# Downtown West

Design Standards  
and Guidelines  
*Errata*

April 15, 2021

# ERRATA

FIGURE 1.4: Downtown West PD Zoning / GDP, EIR, and DWDSG site boundaries

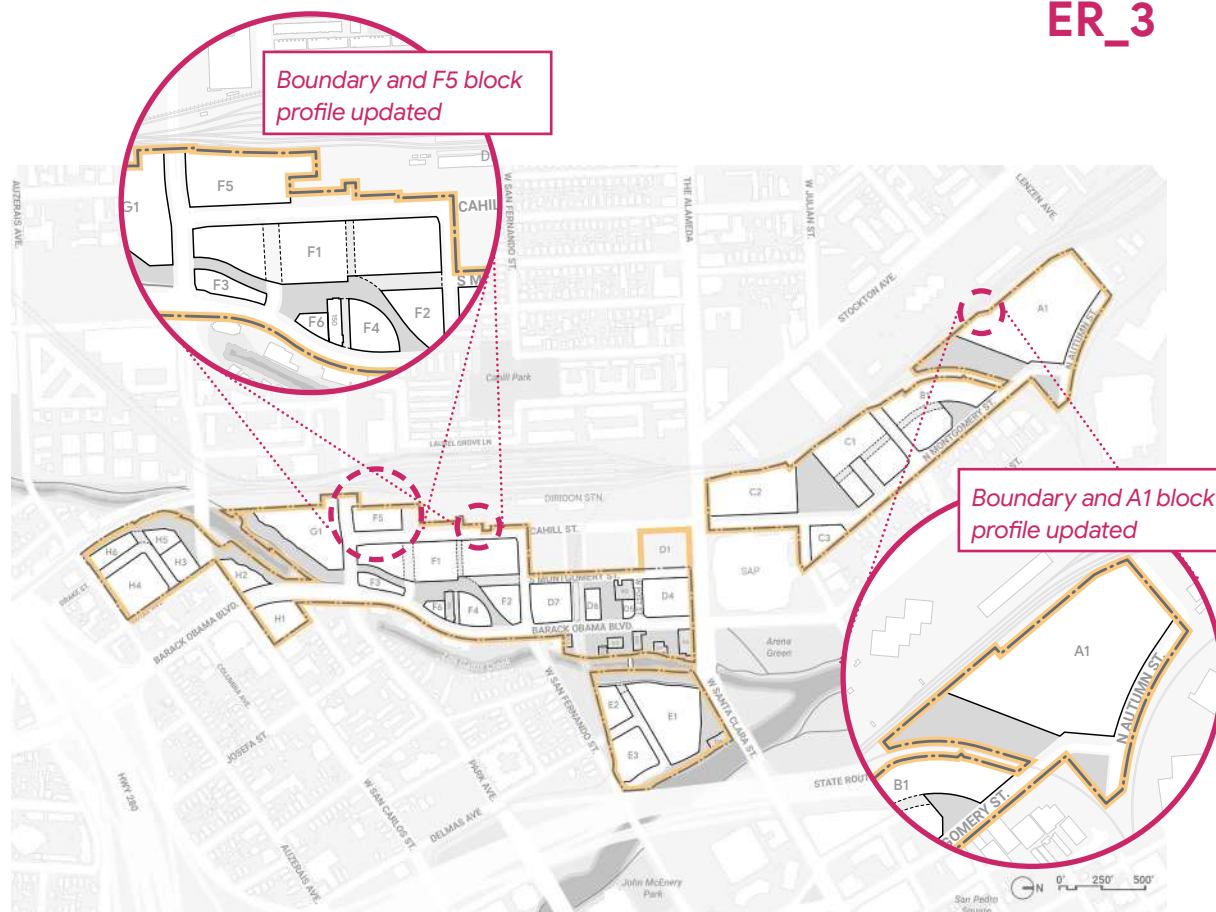
*The updated Project boundary should be considered for all figures in the DWDSG.*

FIGURE 1.8: DWDSG framework plan

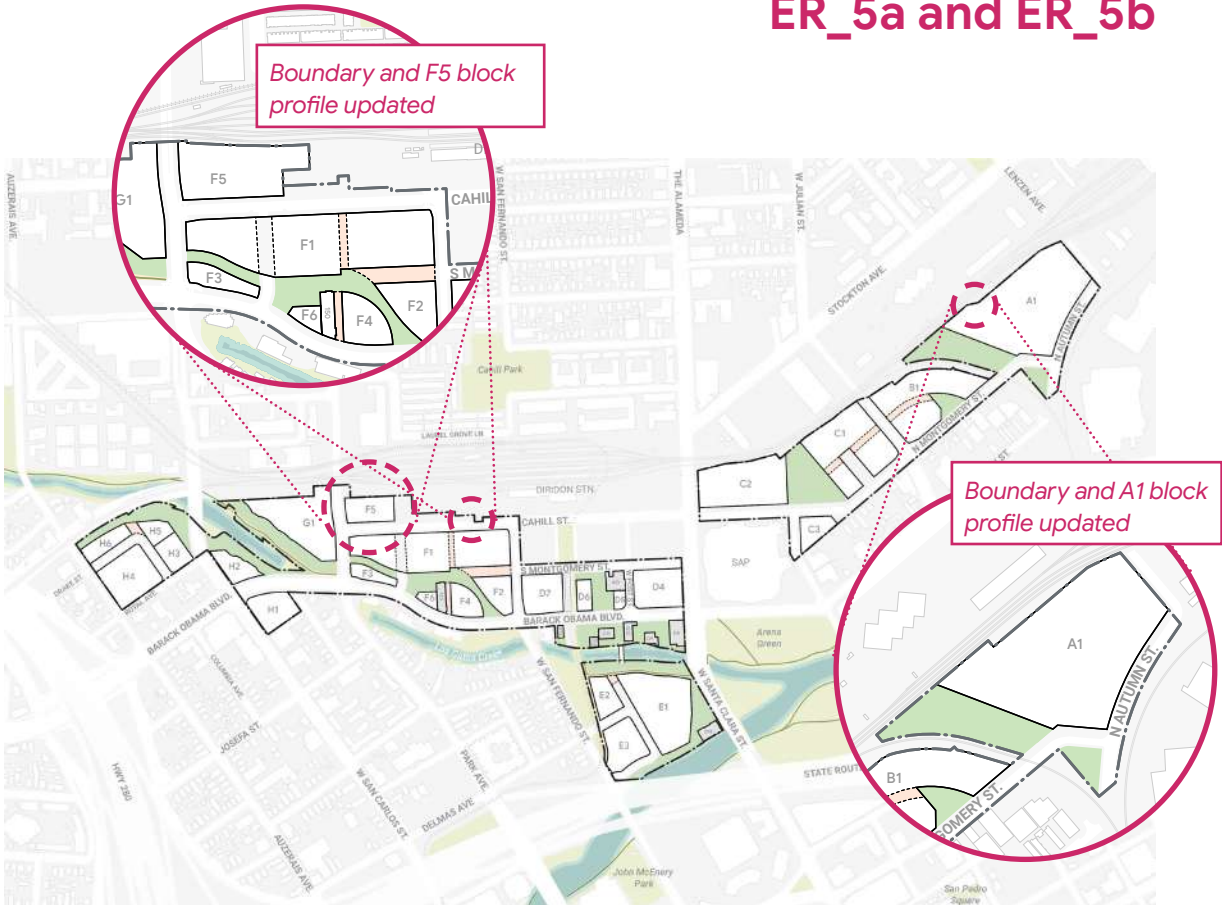
ER_5a	21	Document Overview	Figure 1.8	Site boundary and block profile changes at F5 and A1
ER_5b	21	Document Overview	N/A	The standards and guidelines in the DWDSG permit a limited range of land uses, massing, and circulation options, which may result in a block plan that differs from the DWDSG framework plan. <del>Refer to the Vesting Tentative Map and subsequent Final Maps for dimensioned lot boundaries.</del>
ER_6	30	Project Vision	Figure 2.2	Site boundary and block profile changes at F5 and A1
ER_7	49	Land Use	Figure 3.2	Site boundary and block profile changes at F5 and A1
ER_8	52	Land Use	Figure 3.3	Site boundary and block profile changes at F5 and A1 and southern infrastructure zone boundary extension
ER_9	56	Land Use	Figure 3.6	Site boundary changes and removal of non-building elements identified for demolition
ER_10a	71	Open Space	S4.5.2	“A minimum of 4.80 acres of the approximately 15 total acres of Project open space shall be City-dedicated open space, <del>and shall, at minimum, meet the total acreages shown for Los Gatos Creek Multi-Use Trail and City-dedicated parks identified in Table 4.1. ....</del> ”

The standards and guidelines in the DWDSG permit a limited range of land uses, massing, and circulation options, which may result in a block plan that differs from the DWDSG framework plan.

FIGURE 3.6: Demolition and retention plan

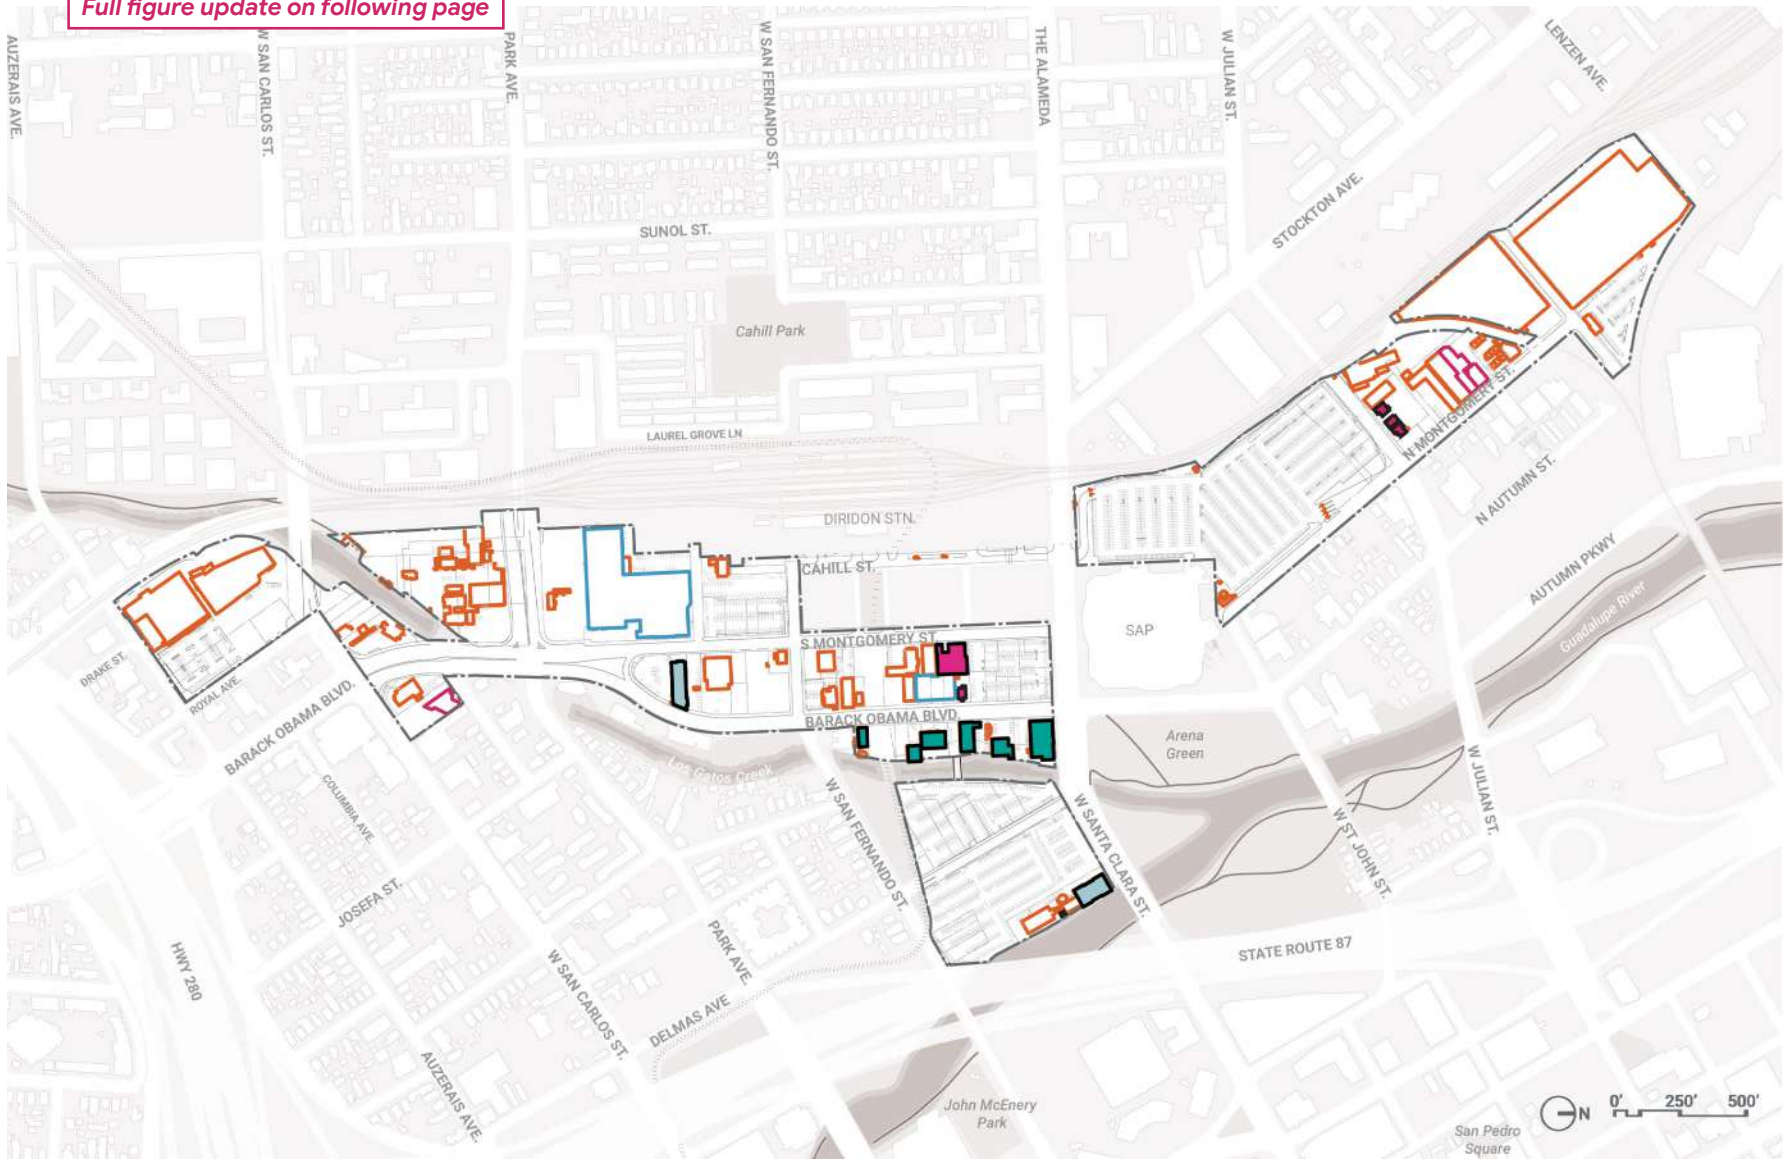
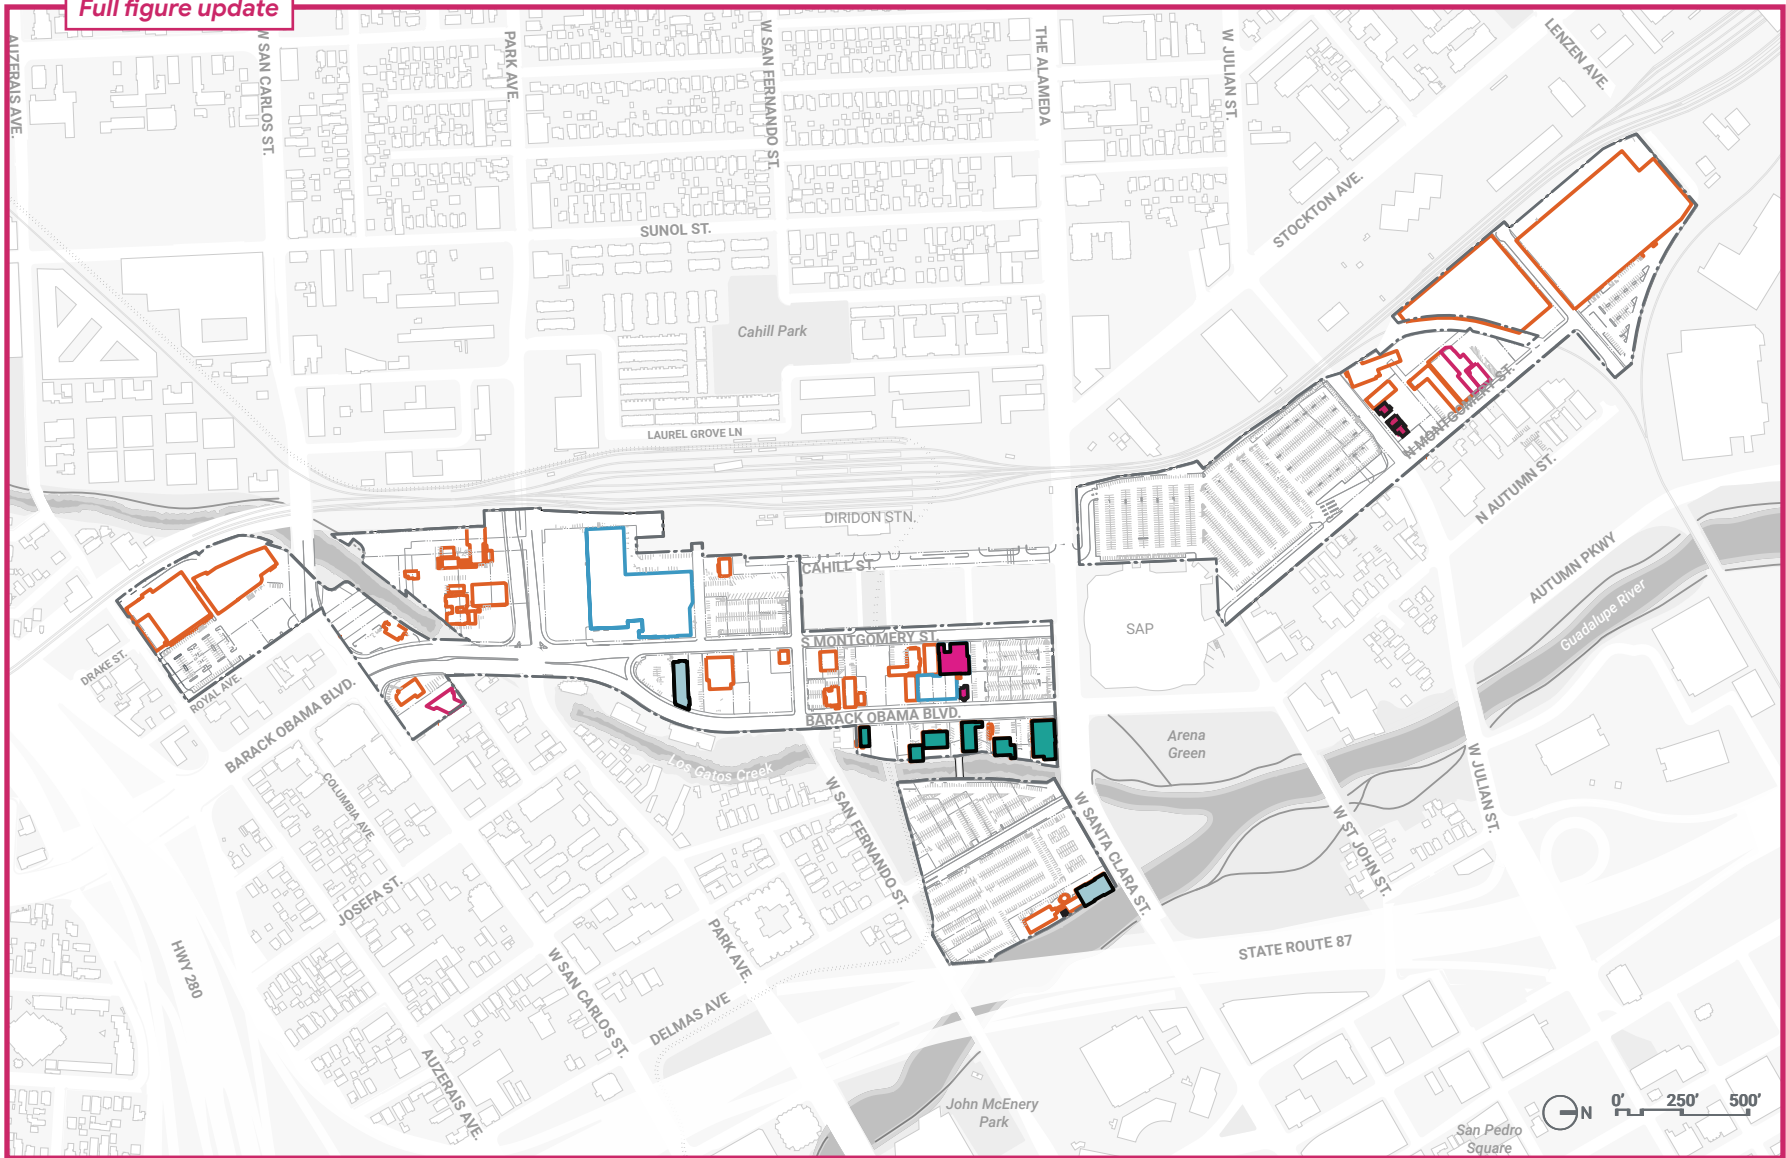
Full figure update on following page

Full figure update

FIGURE 4.49: Illustrative plan of Gateway to San José

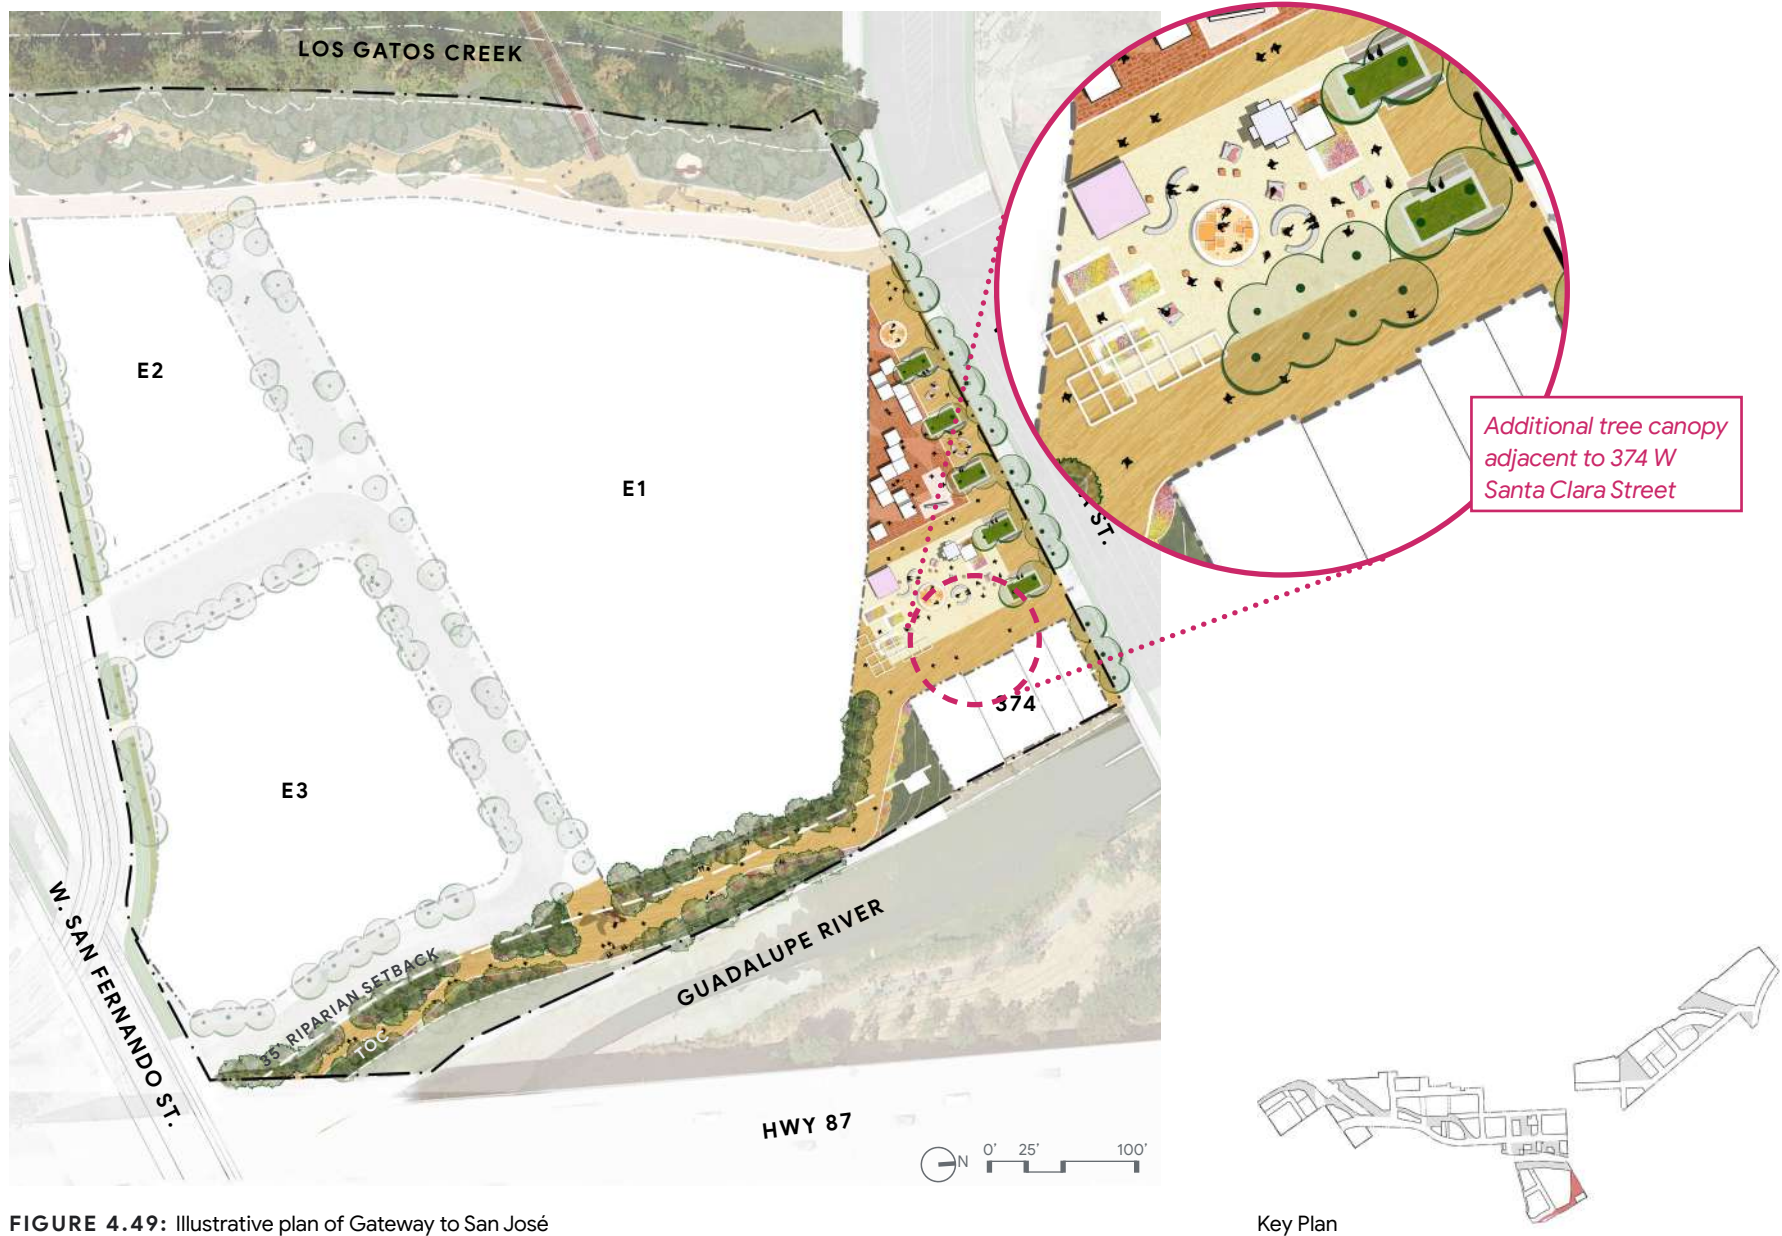
ERRATA ID	DWDSG PAGE NUMBER	DWDSG CHAPTER	DWDSG CONTENT	DESCRIPTION OF UPDATES
ER_10c	134	Open Space	Figure 4.49	Additional tree canopy adjacent to 374 W Santa Clara Street
ER_10d	136	Open Space	Figure 4.50	Additional tree canopy adjacent to 374 W Santa Clara Street
ER_10e	148	Open Space	Figure 4.60	Additional tree canopy adjacent to 374 W Santa Clara Street
ER_11	150	Open Space	Table 4.15	Addition of "California Hazelnut, <i>Corylus cornuta</i> Marsh. var. <i>californica</i> " to plant species list
ER_12	156	Open Space	S4.25.4	"Serviced and unserviced pavilion structure that use glazing as a material shall provide glazing units with visible light transmittance below 60 percent which shall not count toward the required transparent area. <b>Existing structures that are relocated as pavilions shall be exempt from transparency requirements.</b> "
ER_13	156	Open Space	S4.25.6	"Public restrooms, park maintenance and storage facilities, and park management offices shall be permitted supportive structures for <b>open spaces active uses; see Section 3.1</b> . No single park maintenance structure shall exceed 1,500 square feet in interior area. Park maintenance structures shall not exceed 20 feet in height above finished grade as measured to top of roof. Park maintenance structures are permitted in <b>either the open space or the interior of an adjacent building, new development blocks, or other space outside of street right-of-way</b> . If provided as a standalone structure in the open space, the structure size cannot exceed the maximum cover limit described in Table 4.16."

FIGURE 4.50: Required (R) and complementary (C) Gateway to San José programmatic elements diagram

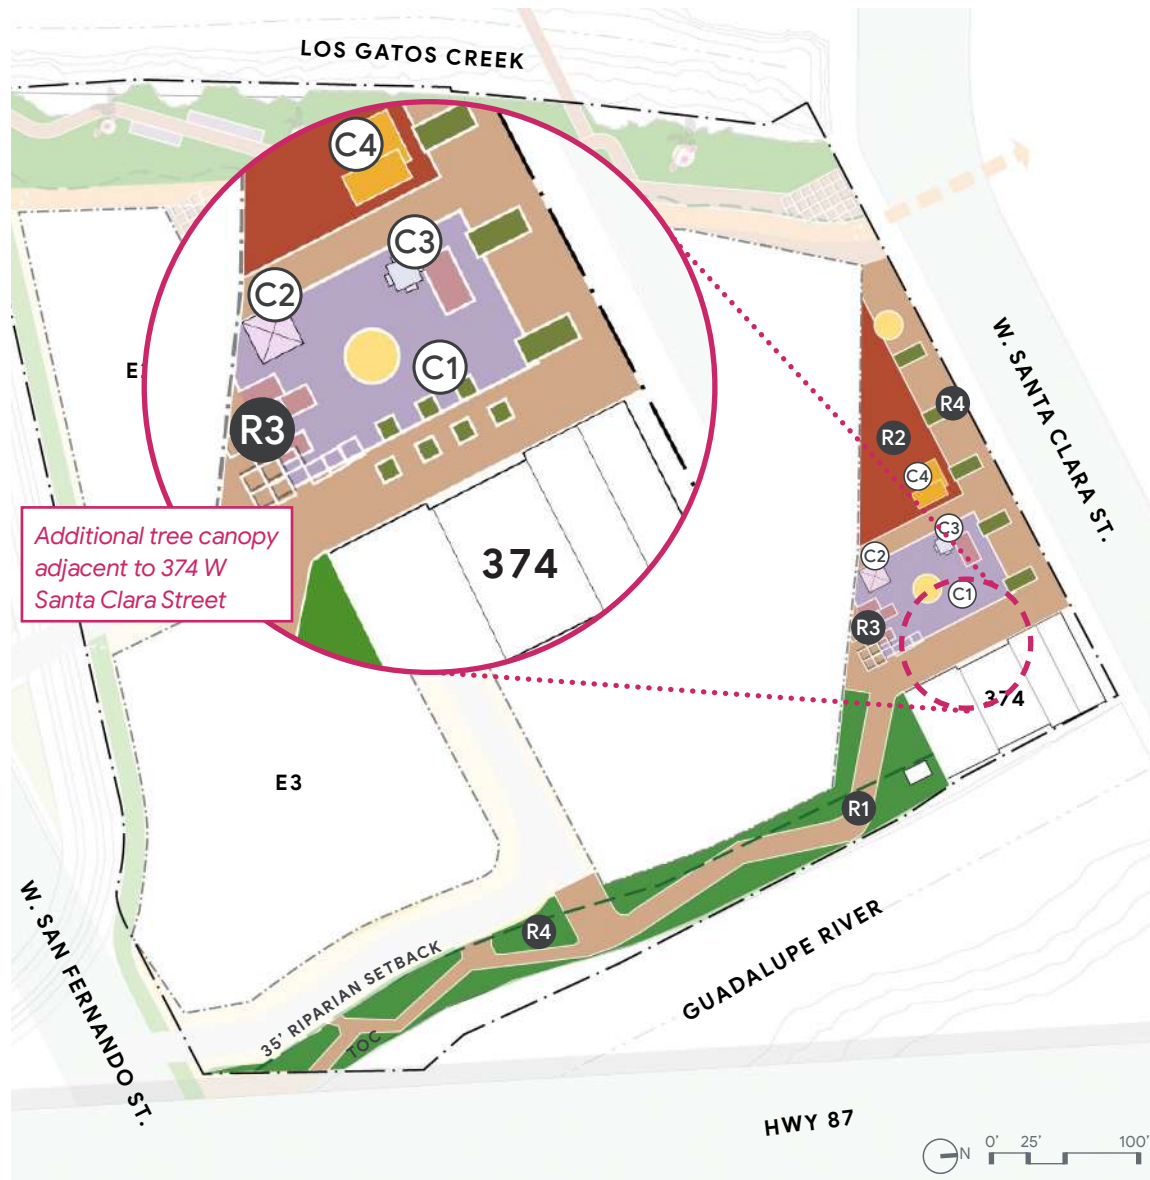
Additional tree canopy adjacent to 374 W Santa Clara Street
